**COMMISSION OF ARCHITECTURAL REVIEW
STAFF REPORT
April 24, 2018, Meeting**

17. **COA-033504-2018** (K. Johnson)

**413 Chimborazo Boulevard
Union Hill Old and Historic District**

Project Description: **Construct a new single family home.**

1925 Sanborn Map

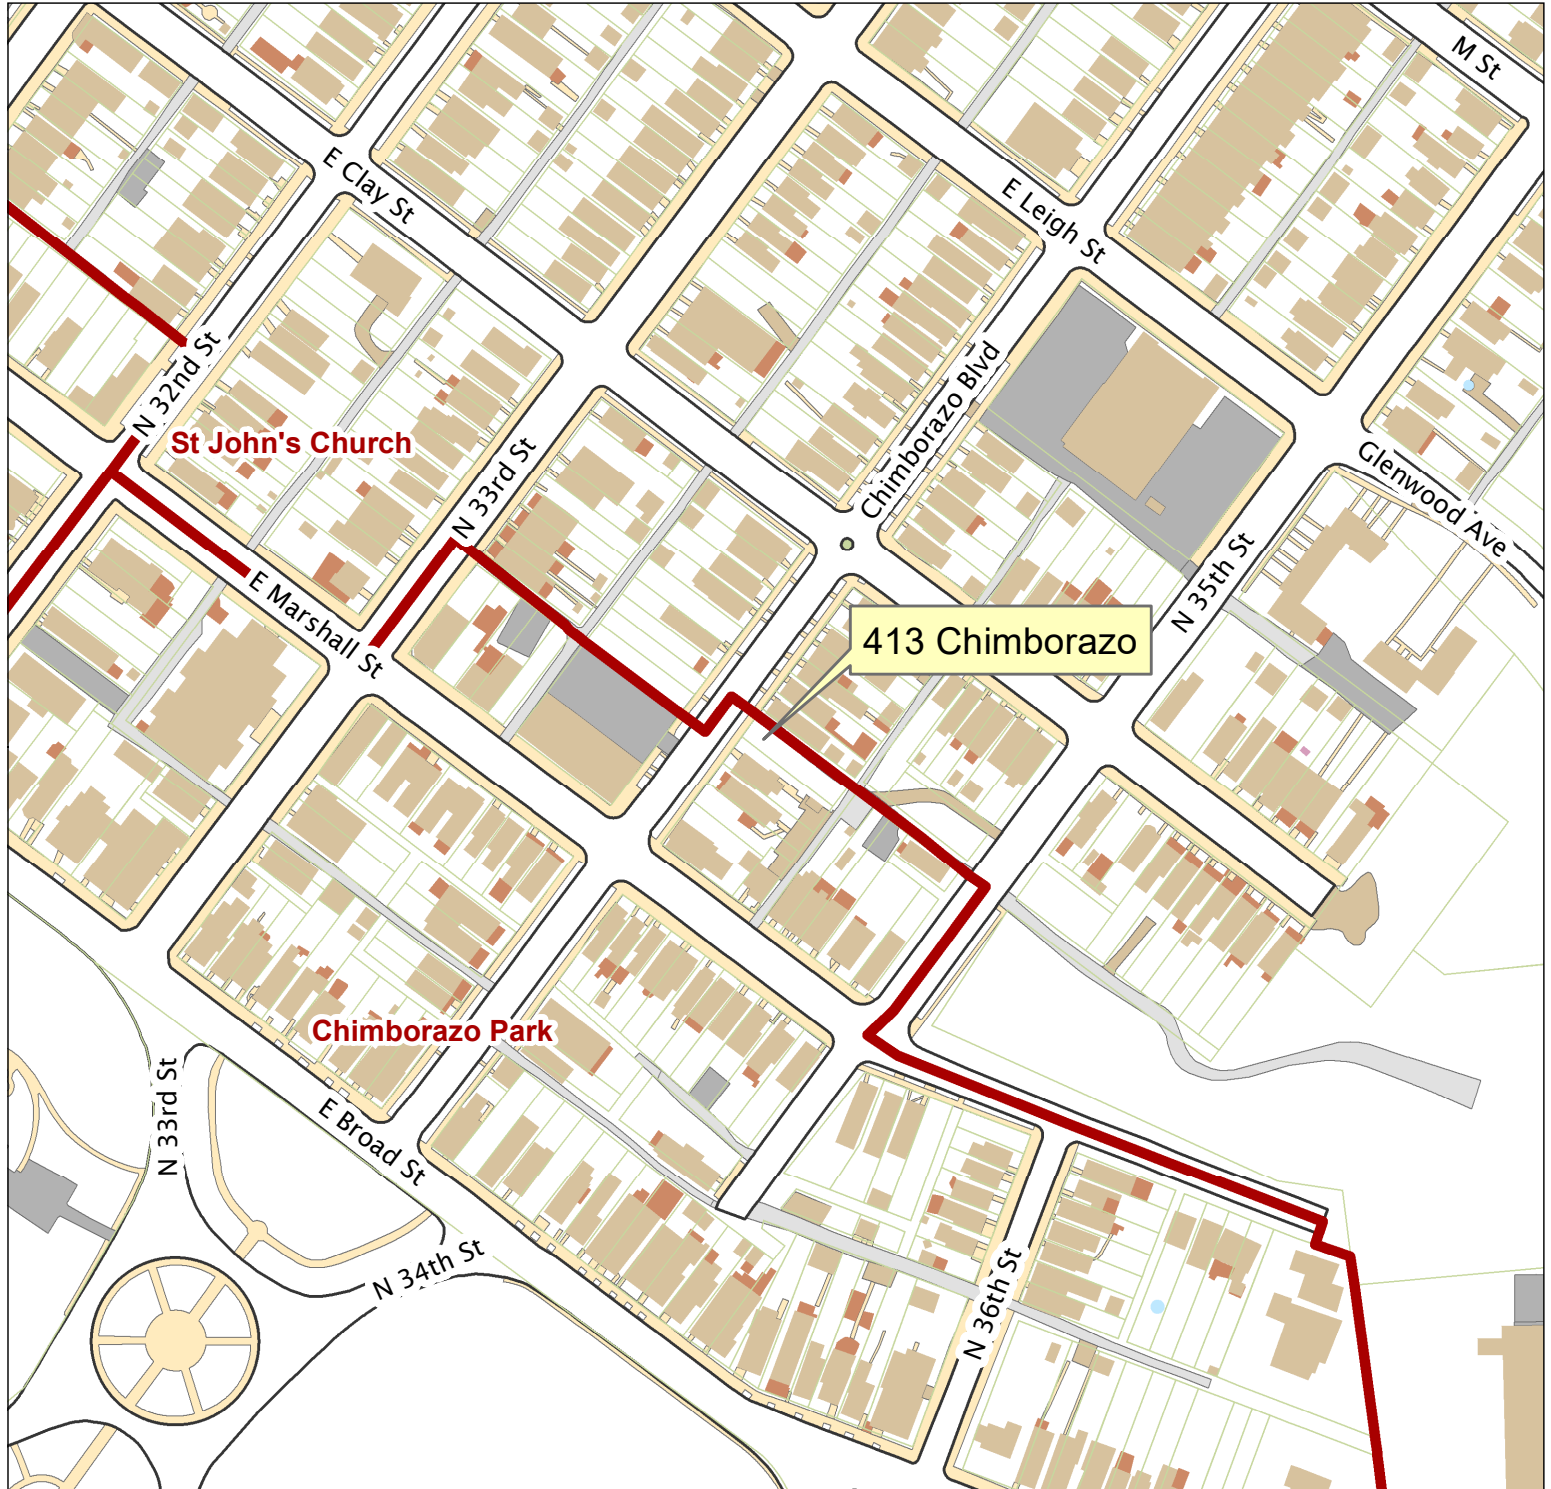
Per the 1925 Sanborn Map, the historic structures on the block have similar front yard setbacks. Staff recommends that the structure should not be sited in front of the structure at 411 Chimborazo Boulevard as to not overwhelm the historic structure.
